# UNITED STATES PATENT AND TRADEMARK OFFICE

## Office Action Summary

10/594,914

### **DETAILED ACTION**

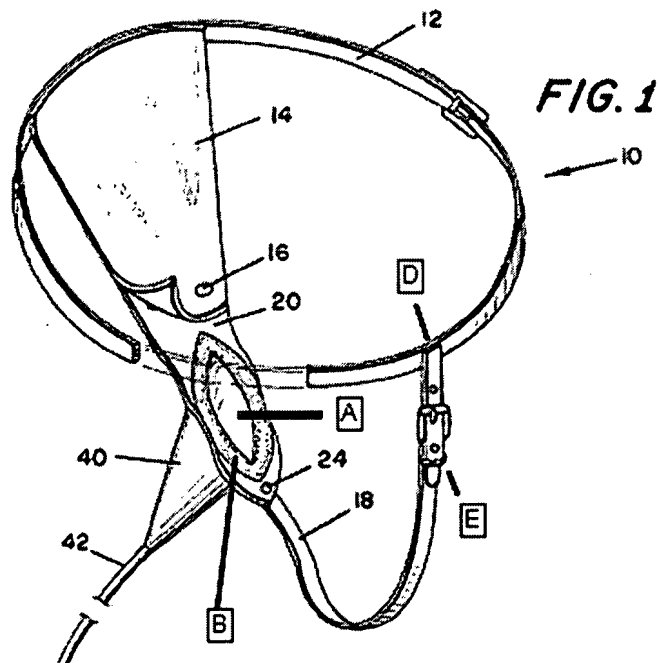
4. In Re claim 1, MAYHORN discloses a non-intrusive female urinary incontinence device comprising a flexible elastic strip (18) having a flat upper face and a lower face, an opening (A) being provided in the strip communicating between the upper and lower faces, a fluid collection means surrounding (B) the opening in a fluid tight manner on the lower face of the strip and means (24) for attaching the device to a supporting means (18), wherein the strip and opening are sized and shaped such that when it is stretch fitted over the external urogenital organs the labia minora extends through the opening and a fluid tight fit between the upper face of the strip and the flesh surrounding the labia minora and around the base of the labia minora is formed, such that in use urine is conveyed from the urethra, through the labia minora, into the collection means without leakage (See Fig. 1).

circumferentially from the surface of the oval region around the opening and curves inwards to a lower open end suitable for communicating with a collection vessel (See Fig 1).

7. In Re claim 8, MAYHORN discloses a device wherein the funnel is integral to the strip (Fig. 1).

8. In Re claim 10, MAYHORN discloses a device wherein the length of said straps is adjustable with respect to the waistband to allow for differences in size and shape of the user (See Fig. 1).

10. In Re claim 12, MAYHORN discloses a urinary incontinence device further comprising a waistband (12) and means (D) for attachment to the device (See Fig. 1).

11. In Re claim 13, MAYHORN discloses a device wherein the attachment means is adjustable to maintain a positive tension on the device when in use (See Fig. 1).

*FIG. 1*

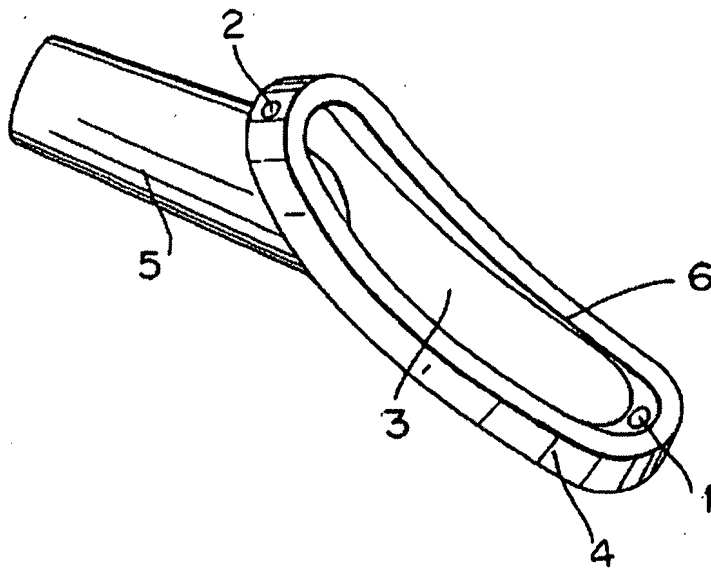
13. MAYHORN/ Giacalone disclose the claimed invention discussed above, but do not expressly disclose the device wherein the anterior surface of the wall of said funnel curves more sharply than the posterior surface, such that the lower opening at the base of the funnel lies in a lower plane than that of the opening in the strip.

14. Birbara teaches that it is known to use the anterior surface of the wall of said funnel curves more sharply than the posterior surface, such that the lower opening at the base of the funnel lies in a lower plane than that of the opening in the strip (See Fig. 1).

15. It would have been obvious to one having ordinary skill in the art at the time the invention was made to modify the funnel of MAYHORN in view of Giacalone with the anterior surface of the wall of said funnel curves more sharply than the posterior surface, such that the

lower opening at the base of the funnel lies in a lower plane than that of the opening in the strip, as taught by Birbara because such modification would improve the hydraulic communication with a collection vessel.

**FIG. 2**

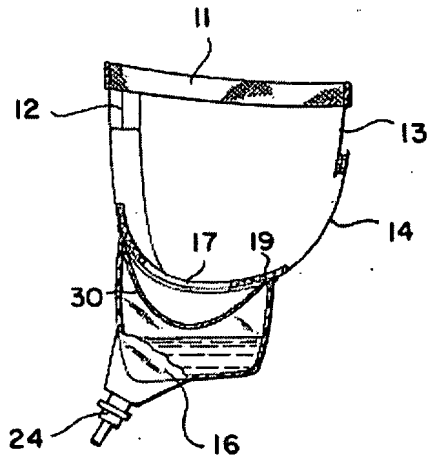
17. MAYHORN/ Giacalone disclose the claimed invention, but do not expressly disclose the funnel has a double-walled structure, the inner curved wall narrowing symmetrically and more sharply than the outer wall so that an internal opening is formed substantially parallel to and of smaller radius than the opening in the strip.

18. Bermingham teaches that it is known to use the double-walled funnel, the inner curved wall narrowing symmetrically and more sharply than the outer wall so that an internal opening is formed substantially parallel to and of smaller radius than the opening in the strip (See Col. 2, ln. 57-61; Fig. 2).

19. It would have been obvious to one having ordinary skill in the art at the time the invention was made to modify the device of MAYHORN in view of Giacalone with the double-walled funnel, as taught by Bermingham because such modification would prevent the urine from flowing back into the interior opening.

22. Bermingham teaches that it is known to use a cavity is formed between the posterior surface of the inner wall and the posterior surface of the outer wall such that, when the user is in a horizontal position, urine which has passed through the internal opening of the hel is prevented from flowing back into the cavity between said opening and the oval opening of the strip (See Col. 2, ln. 57-61; Fig. 2).

24. In Re claim 6, Bermingham discloses the device wherein the inner wall and outer wall are spaced apart such that urine in the cavity is prevented from flowing back into the interior opening ((See Col. 2, ln. 57-61; Fig. 2).

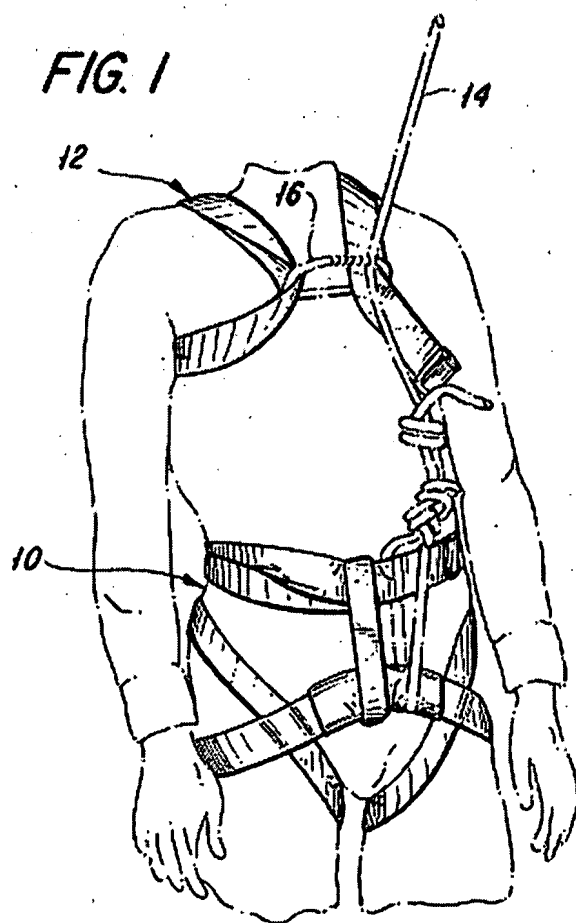
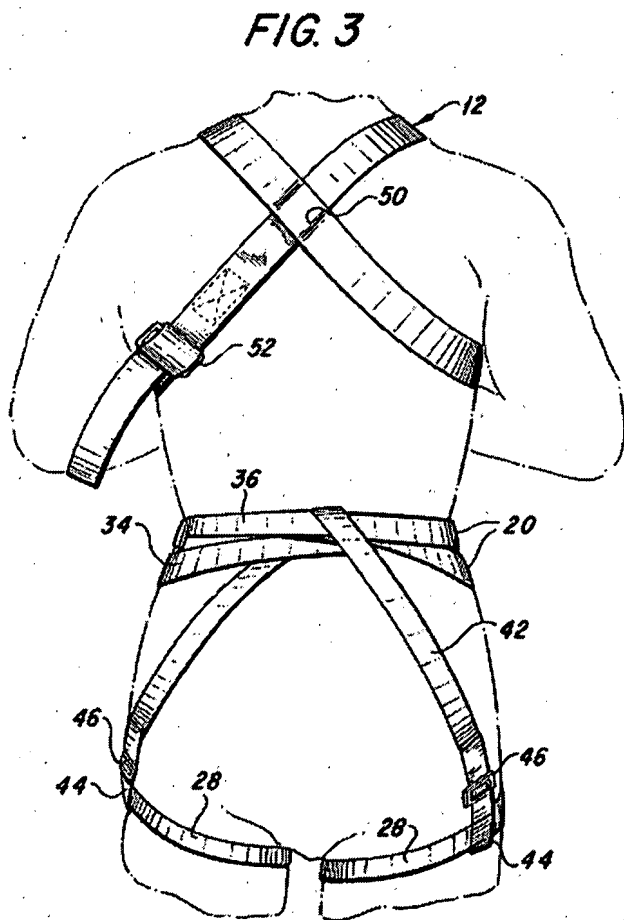
28. MAYHORN/ Giacalone disclose the claimed invention, but do not expressly disclose the strip comprises divergent elongated straps at the front and rear to provide anterior and posterior support straps for attachment to a supporting waistband, so that in use the strip is stretched tightly over the external urogenital organs.

29. Markwell teaches that it is known to use a support system comprising of the strip comprises divergent elongated straps at the front and rear to provide anterior and posterior support straps for attachment to a supporting waistband (See Figs. 1 and 2).

30. It would have been obvious to one having ordinary skill in the art at the time the invention was made to modify the device of MAYHORN in view of Giacalone with the strip comprises divergent elongated straps at the front and rear to provide anterior and posterior support straps for attachment to a supporting waistband, as taught by Markwell because such modification would improve the maintenance of the positive tension on the device when in use.
